DATE: December 22, 2020
SUBJECT: Letter of Clarification 2
RE: Request for Competitive Sealed Proposals for Construction Contract for Lynn Wyatt Square Project
TO: All Prospective Proposers

Houston First Corporation (“HFC”) issues this Letter of Clarification 2 regarding the referenced Request for Competitive Sealed Proposals for Construction Contract for Lynn Wyatt Square Project to make certain clarifications to the solicitation and answer questions timely received in the manner set forth below:

Figure 1. R-4 Rail Location 1

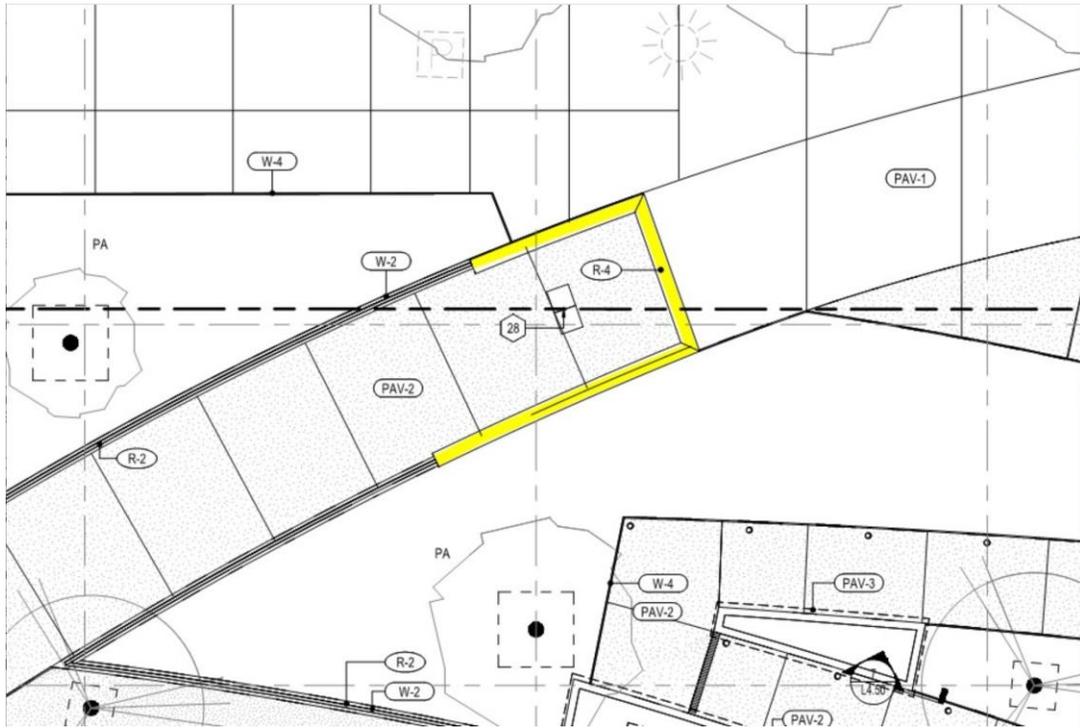
Question 5: Please provide sections through handrails/guardrails on Sheets L1.10 through L1.13 to clearly identify where the Douglas Fir Armrest per 1, 2, and 3/L4.35 occurs.

Answer: R-4 (Douglas Fir Armrest) is called out on Enlargement plans - sheets L1.13 and L1.11. For further clarification, please see Attachment A, Figures 1 and 2.

Figure 3. Pit Access Ladder

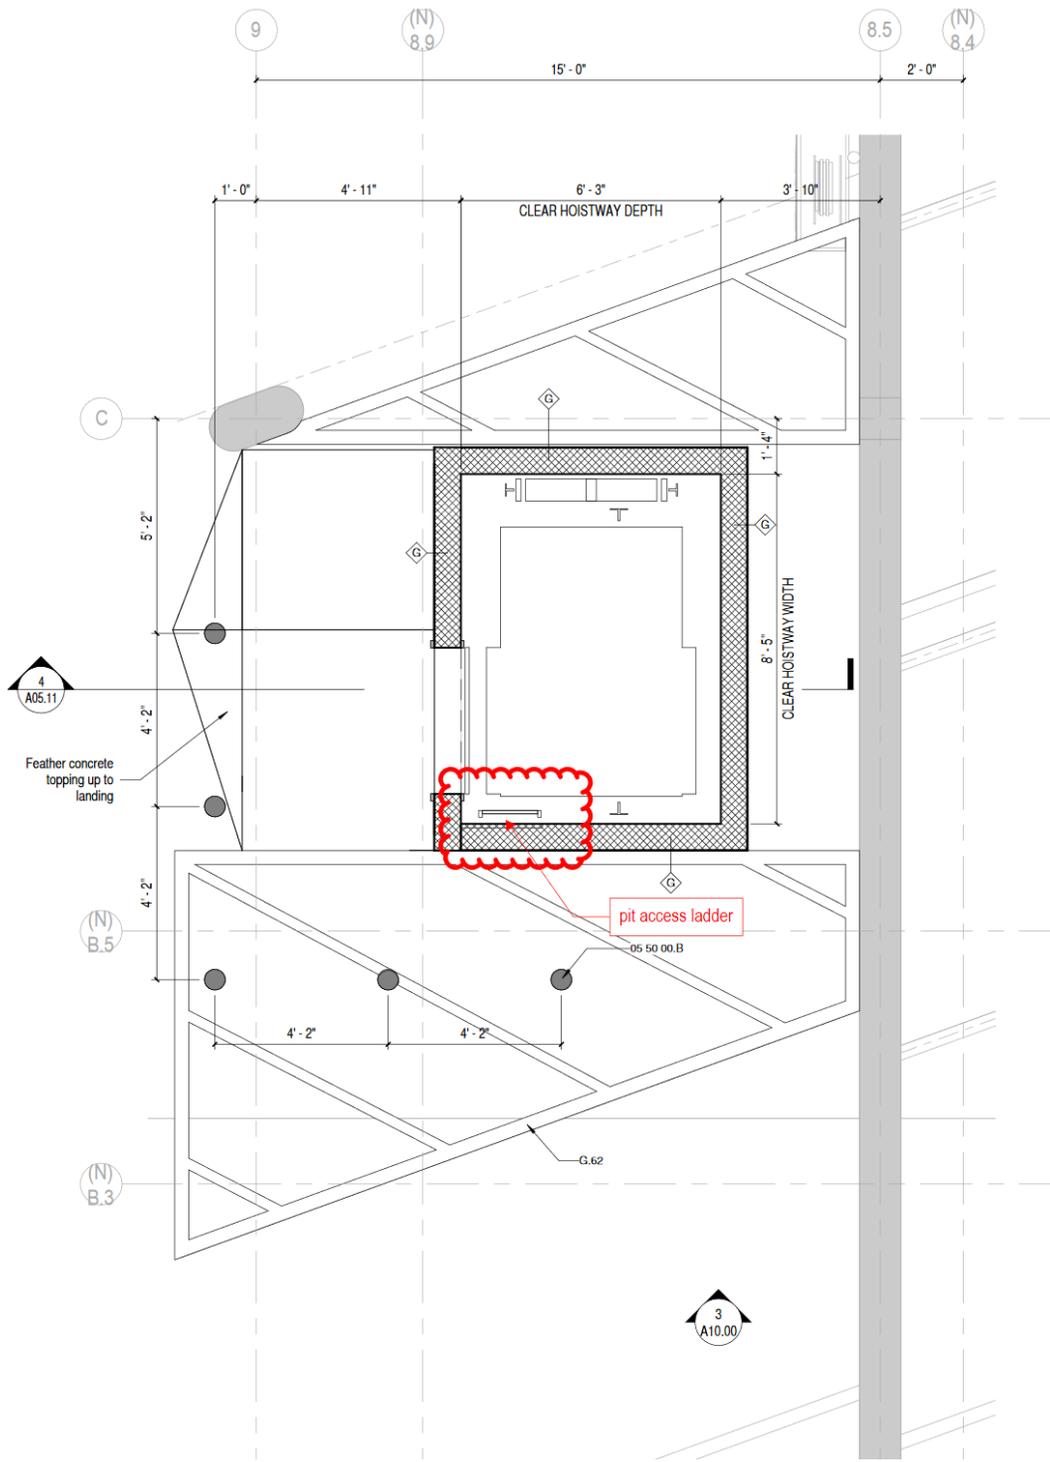
Question 11: a) Please advise on the access to the elevator pit/composite deck between Level B2 and B3. Sheets A00.03 and A10.00 do not appear to indicate the access to the pit. b) Please advise if an Elevator Pit Ladder is required.

Answer: Elevator pit ladder is required. Ladder is graphically shown on 5/A05.11, but is missing a note. For clarification, please see Attachment A, Figure 3.

Figure 4. Elevator Guide Rail

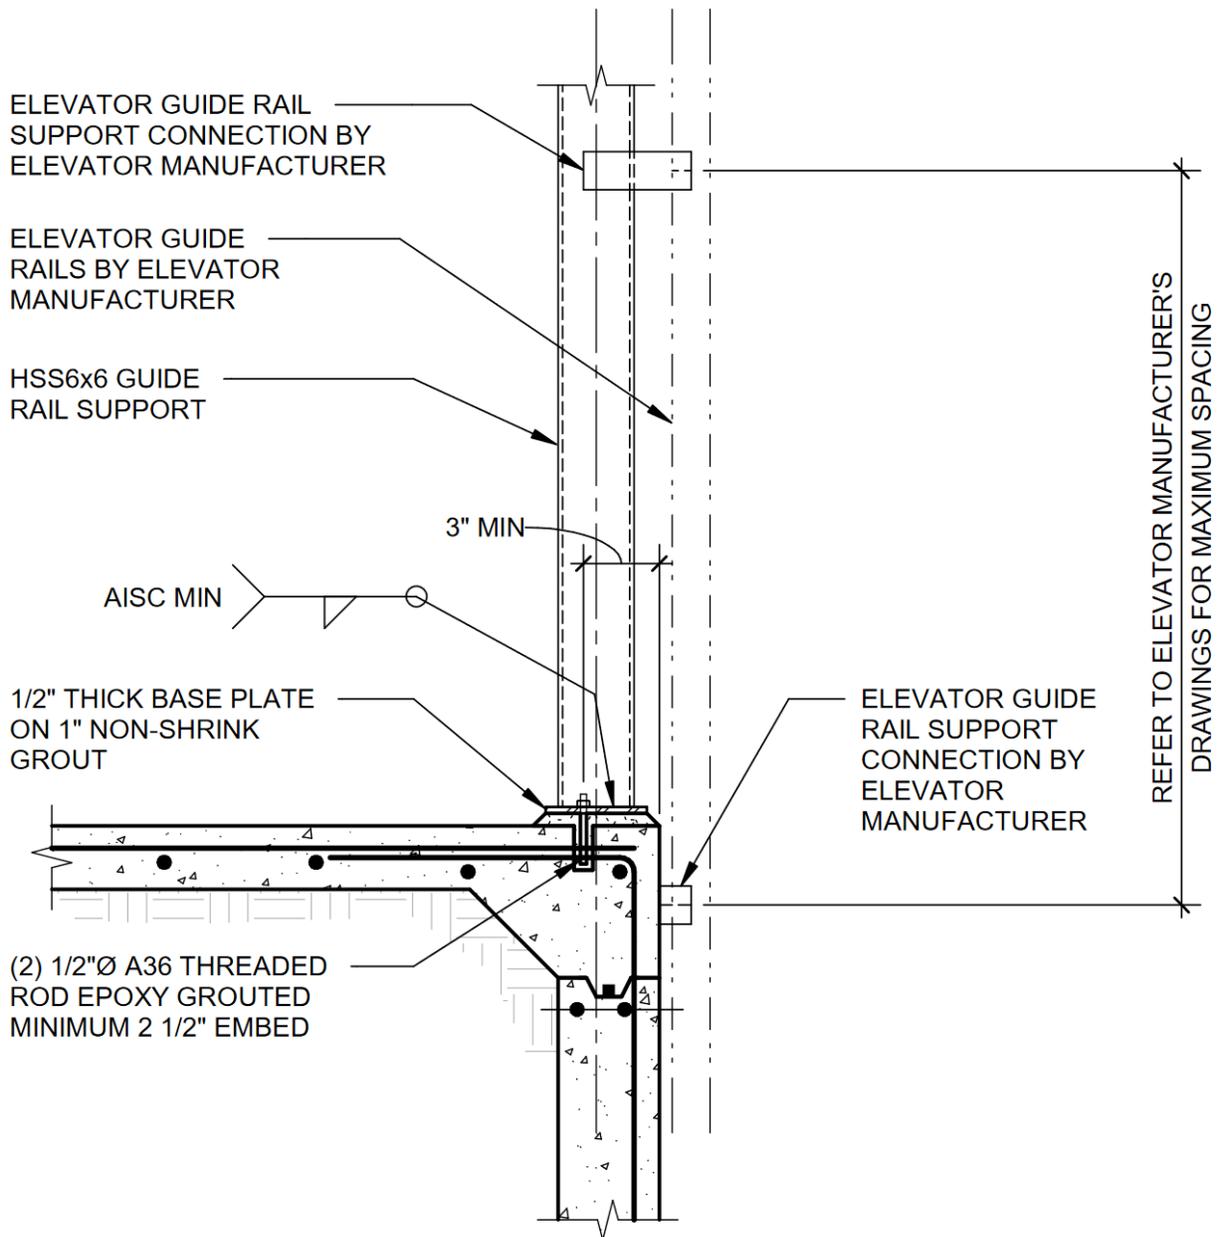
Question 12: Please provide information and details for elevator guide rail supports at the restaurant structure

Answer: Vertical guide rail supports are to be HSS6x6x1/4, where required. Generally, the elevator shaft walls are CMU which will support the guide rails. Please see Attachment A, Figure 4 for typical detail.
